Project  
**90 PLACE CHILD CARE CENTRE**  
 7-11 MURRAY ST & 25 GILLESPIE ST  
 WANDAL, QLD.

Our Ref: 21480-L02-RFI

**25 Gillespie Street & 7,11 Murray  
Street, Wandal QLD 4700**  
Engineering Report & Stormwater  
Management Plan

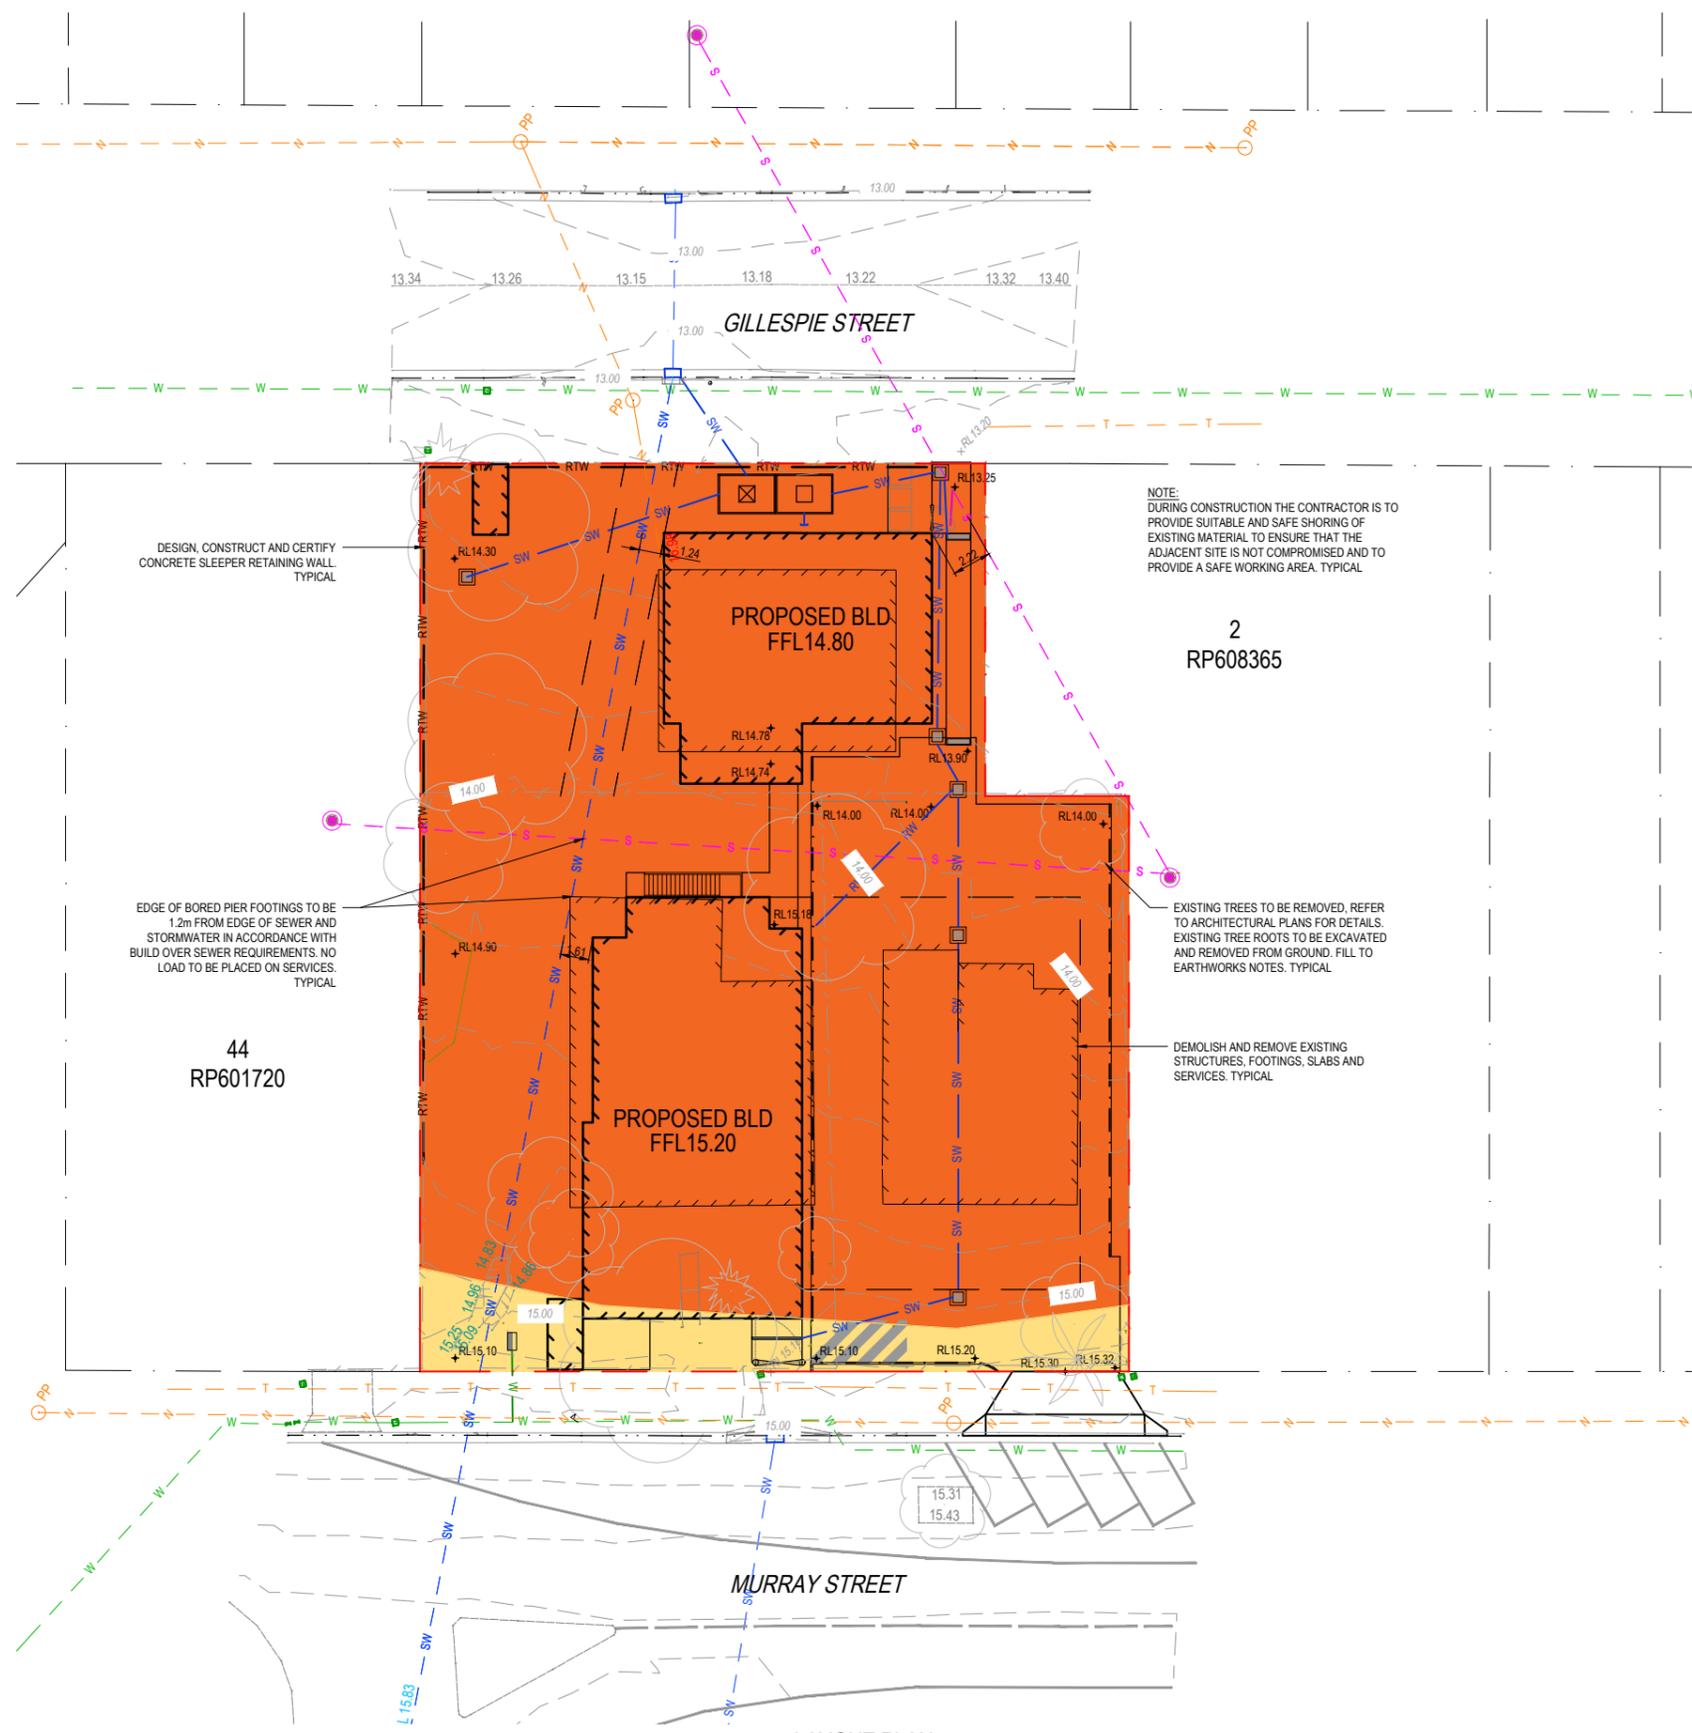
1.1 Provide updated proposal plans that show the two (2) storey building, including roofing, separated a minimum of 1.5 metres(m) from the centre line of existing trunk stormwater infrastructure (600mm diameter main).

1.2 Provide a section drawing of the encroachment of the single storey building into the existing drainage easement (north) and over the 150mm sewer reticulation main (south), which details the height of the roof and distance encroached into the easement/ over the sewer reticulation main.

A note on the 'Preliminary Bulk Earthworks – Layout Plan', drawing P200 Revision B, indicates the edge of the bored pier footing to be 1.0m from edge of the sewer and stormwater infrastructure, however, this is to be 1.2m in accordance with QDC MP1.4.

As shown on drawing P200/C and architectural drawings, the building is more than 1.5m from the centre line of the pipeline.

As shown on drawing P200/C and architectural drawings, the building does not encroach into the easement.

As shown on drawing P200/C, the bored piers are more than 1.2m from the edge of the buildings.

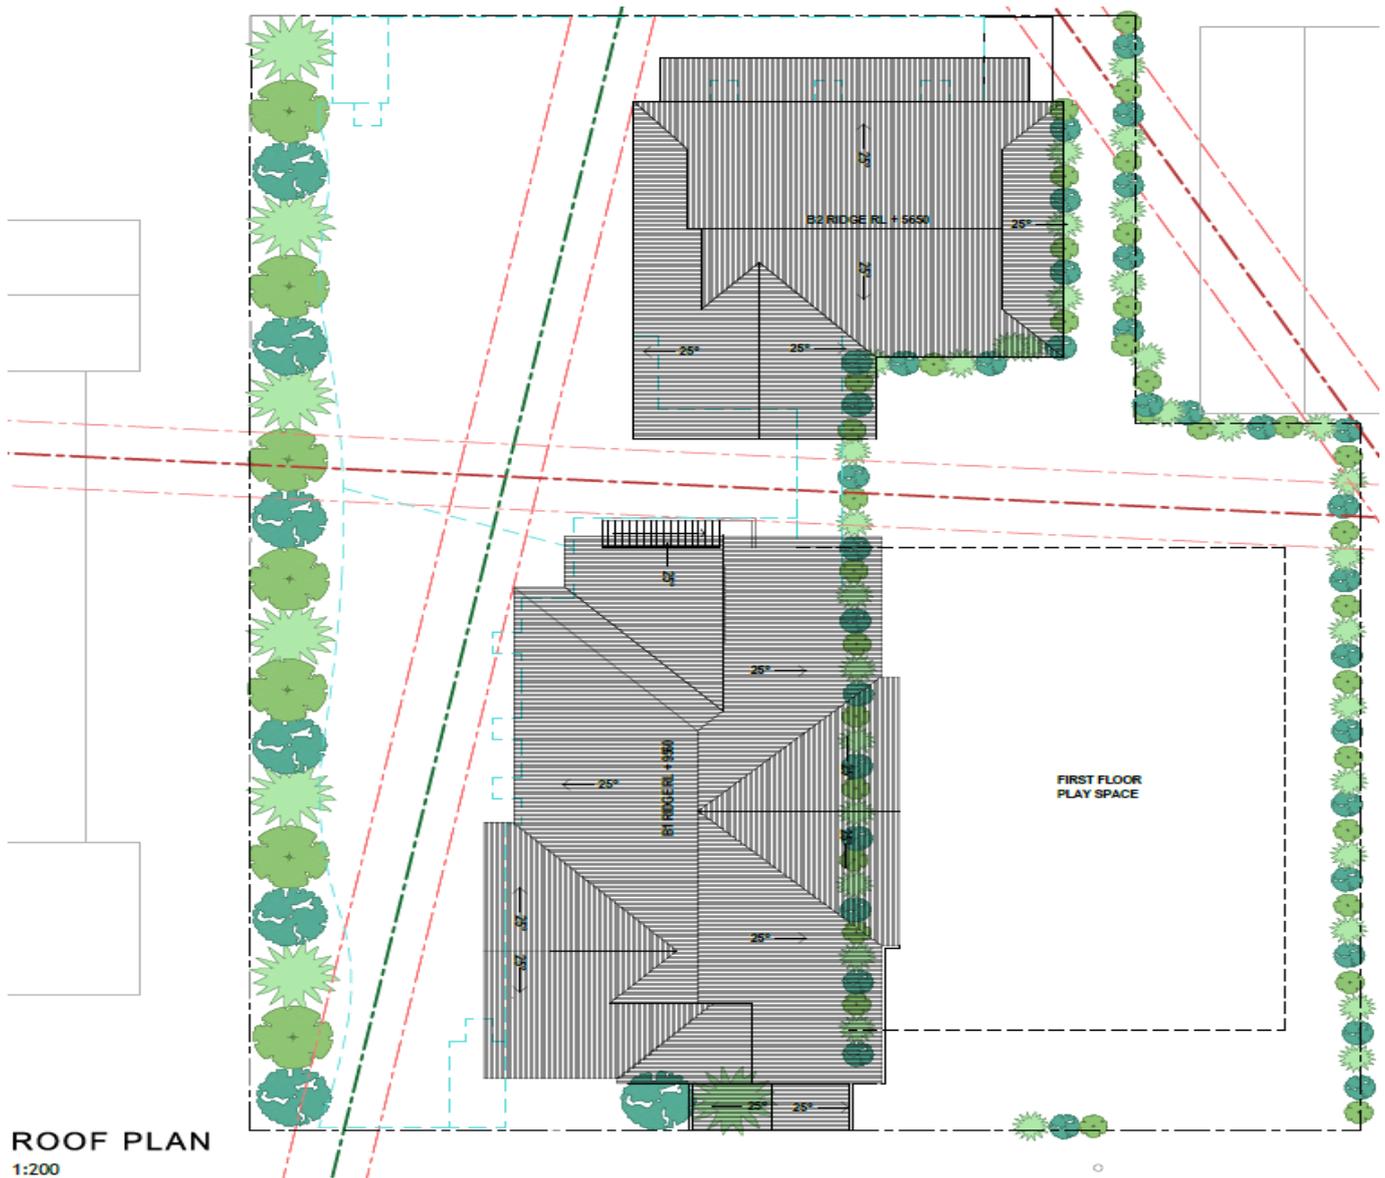
1.4 Demonstrate the proposed development complies with *Queensland Development Code (QDC)*, Mandatory Part 1.4 "Building over or near relevant infrastructure". A note on the 'Preliminary Bulk Earthworks - Layout Plan', drawing P200 Revision B, indicates the edge of the bored pier footing to be 1.0m from edge of the sewer and stormwater infrastructure, however, this is to be 1.2m in accordance with QDC MP1.4.

Refer to the Amended Proposal Plans at **Attachment 2** which include the revised roof design, modified to eliminate the encroachment into the 1.5m area measured from the centreline of the existing trunk stormwater infrastructure (See **Extract 1** below).
